Public comment response

Re: Project File #608020 Cape Cod Bridges Project

However, the current design for the multimodal facility on the Bourne South Quadrant presents significant unaddressed impacts to the human and natural environment. This comment highlights the issues and proposes a design modification, and requests a preliminary design & cost estimate (capital & operating) Thafor it.

Figure 2 - Location of proposed overpass versus existing path plan

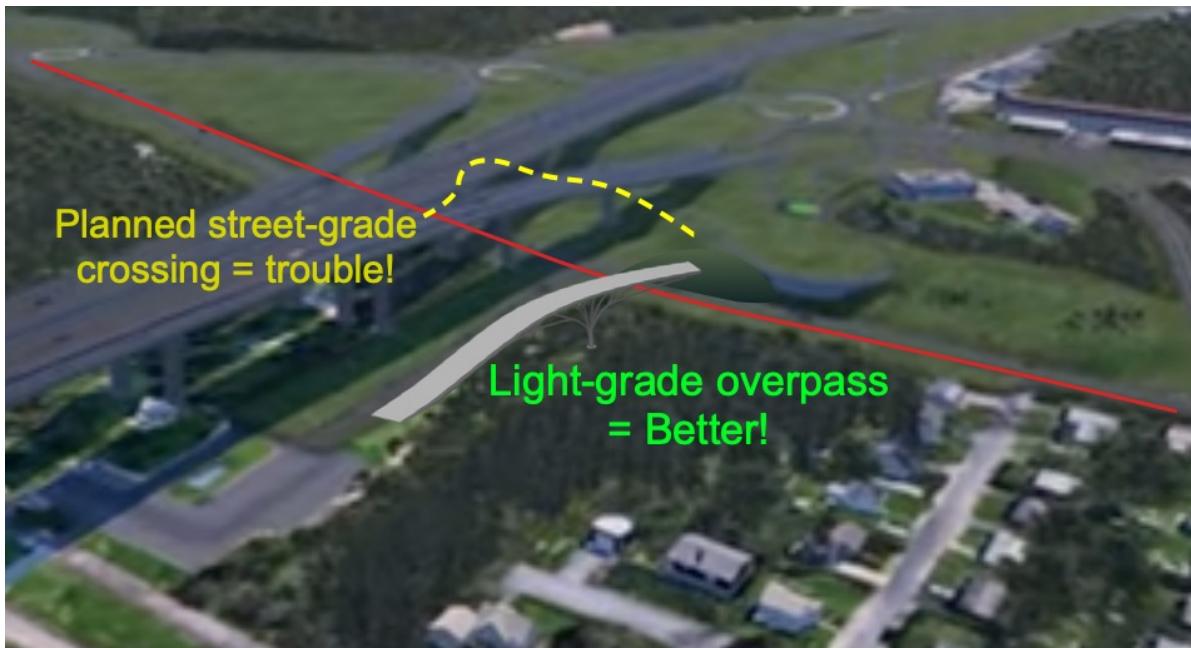
A light, ramped, grade-separated bike & walker overpass is a simple cost-effective solution that **eliminates the problems entirely**. An overpass can leverage existing site elevation and the already-planned retaining wall to descend towards the canal into the Bourne Recreational Area. Figure 2 illustrates this.²

This overpass constitutes a reasonable design alternative that meets the project's purpose and need while reducing adverse effects on both the human and natural environment. The benefits are clear:

- **Improves safety unequivocally.** The overpass entirely removes the interaction between bikes, walkers and drivers.
- **Further encourages usage.** Eliminating fear of car collisions makes all users happier, resulting in increased year-round use by locals and visitors.
- **Better supports event surges.** Large-scale events can proceed without closing the Canal Service Road or requiring law enforcement control. Smaller events won't cause frequent traffic stops.
- **Improves site impact.** Utilizing existing right-of-way maintains land alignment, leverages the descending elevation, and eliminates extra berms and erosion control.
- **Simplifies canal bike path connection.** The overpass can safely exit near most users' destination - the bike path.

Figure 3 - Descent grade eliminated

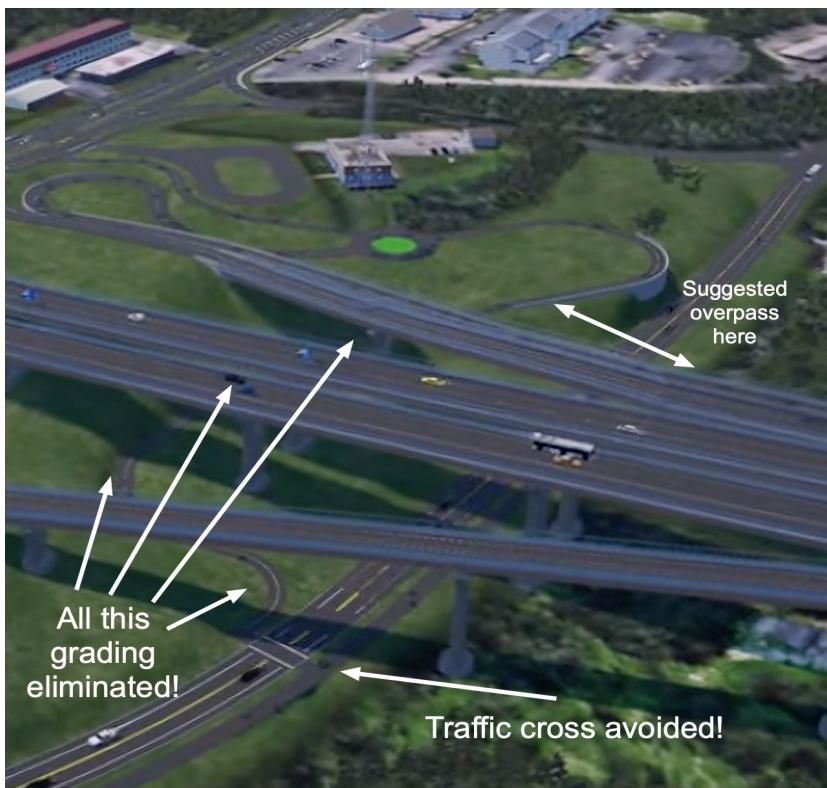
- **The change leverages planned structures.** A structural berm and major path descent are already included in the current plan; these elements can be reworked to form the southerly approach to the overpass. The northerly descent can be accommodated by a light, non-vehicular structure. Note: A U-shaped ramp might be required due to the elevation descent required.

- **No new property required.** The northern side of the overpass, which constitutes the descent over grade, can descend into the existing Bourne Recreation Area and Cape Cod Canal District property. No property taking is required. See rough placement illustrated in Figures 3 & 4.
